POWER PLANT - ENGINE - EGT HARNESS - INTRODUCTION OF IMPROVED CLIPPING FOR CLIPPING
POINTS 5734, 5735 AND 5736 - CATEGORY CODE 4 - MOD.ENG-71-0061

V2500-ENG-71-0061

SERVICE BULLETIN

Location of the clipping points 5734, 5735 and 5736 and clipping arrangement
Fig.1

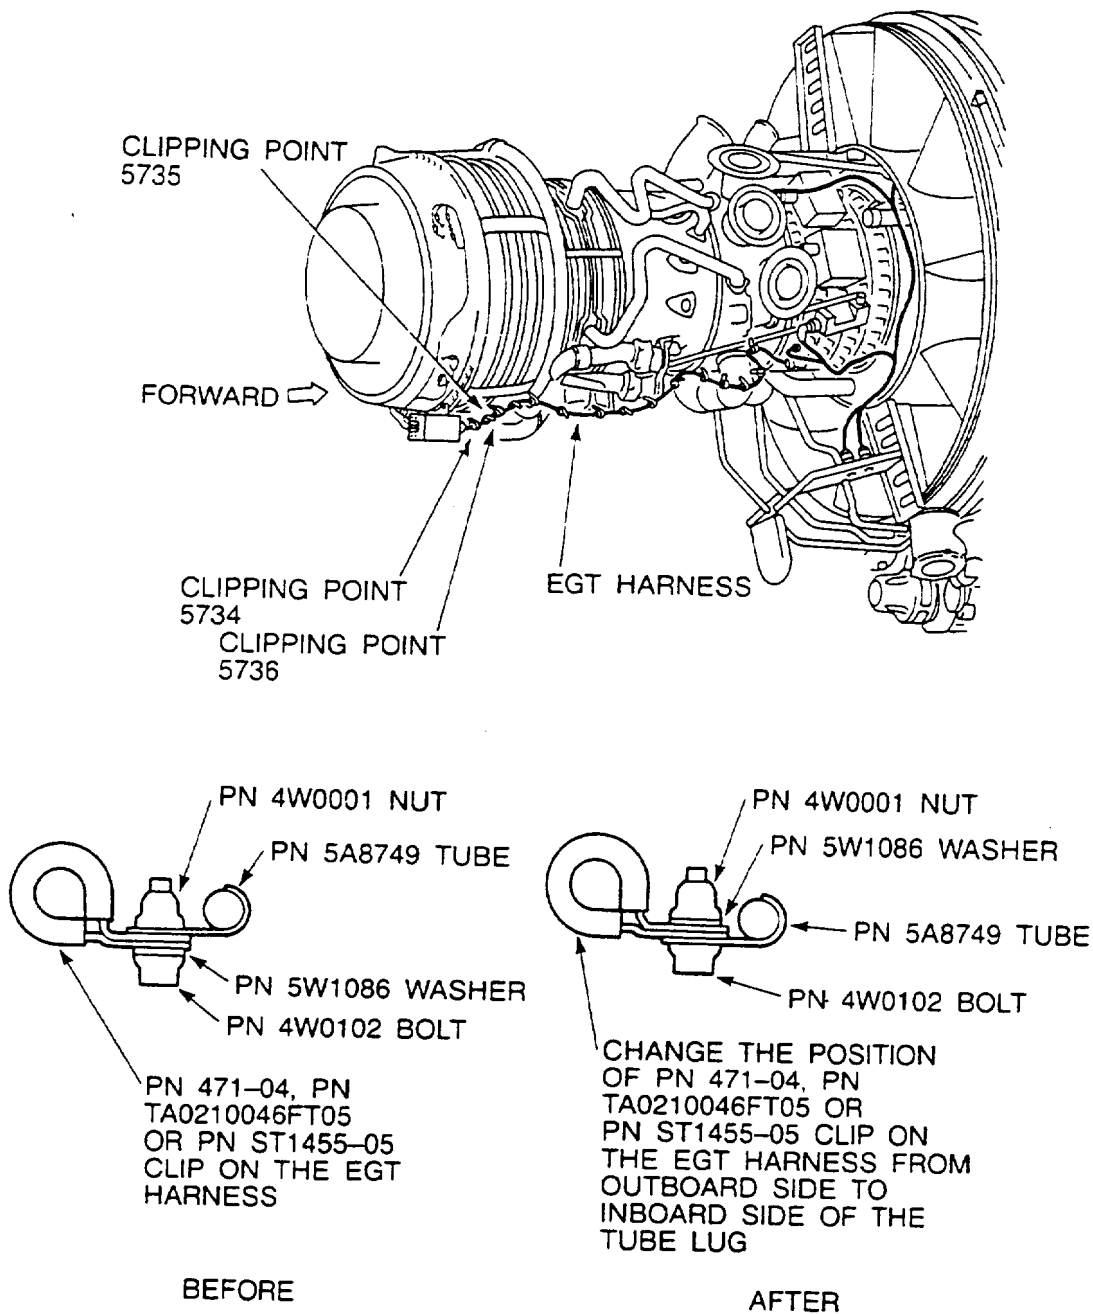
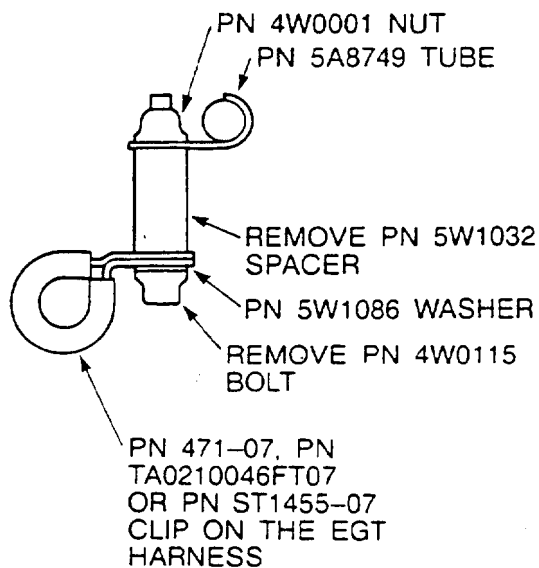
- (a) Spacer length and bolt length are changed to short ones at clipping point 5734. 5W1030 Spacer supersedes 5W1032 Spacer. 4W0109 Bolt supersedes 4W0115 Bolt.
- (b) A spacer is added for clipping point 5735 and bolt length change follows that. 5W1030 Spacer is added and 4W0109 Bolt supersedes 4W0102 Bolt.
- (c) The clip is transferred from the outboard to the inboard side of the tube lug at clipping points 5735 and 5736.

- (3) Change position of clip at clipping point 5736.
 - (a) Remove 4W0001 Nut, 5W1086 Washer and 4W0102 Bolt and release 471-04, TA0210046FT05 or ST1455-05 Clip with the EGT harness from the lug of 5A8749 Tube.

- (b) Reinstall the clip to the inboard side of the lug using 4W0102 Bolt, 5W1086 Washer and 4W0001 Nut.

(c) Torque the nut to 36 to 45 lbfin (4 to 5 Nm).

CLIPPING POINT 5734

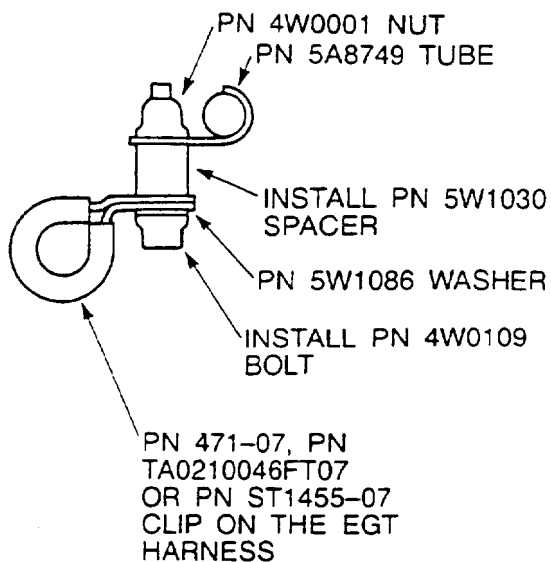
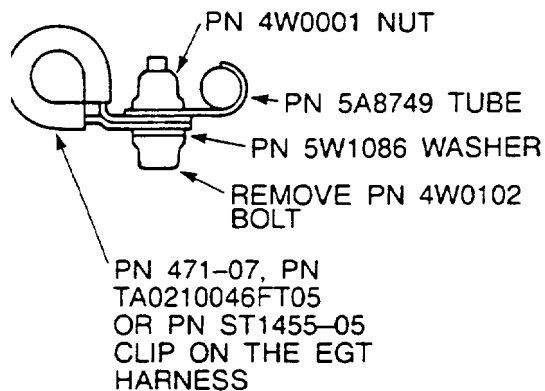
- (1) Replace spacer and bolt at clipping point 5734.
 - (a) Remove 4W0001 Nut, 5W1086 Washer, 5W1032 Spacer and 4W0115 Bolt and release 471-07, TA0210046FT07 or ST1455-07 Clip with the EGT harness from the lug of 5A8749 Tube.

- (b) Reinstall the clip using new 4W0109 Bolt, 5W1086 Washer, new 5W1030 Spacer and 4W0001 Nut.
 - (c) Torque the nut to 36 to 45 lbfin (4 to 5 Nm).
- (2) Add spacer and replace bolt at clipping point 5735.

CLIPPING POINT 5735

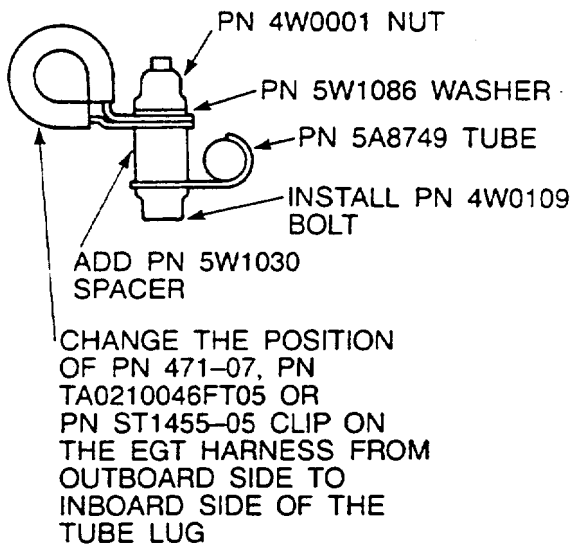
- (a) Remove 4W0001 Nut, 5W1086 Washer and 4W0102 Bolt and release 471-07, TA0210046FT05 or ST1455-05 Clip with the EGT harness from the lug of 5A8749 Tube.

- (b) Reinstall the clip to the in board side of the lug using new 4W0109 Bolt, 5W1086 Washer, added 5W1030 Spacer and 4W0001 Nut.
 - (c) Torque the nut 36 to 45 lbfin (4 to 5 Nm).
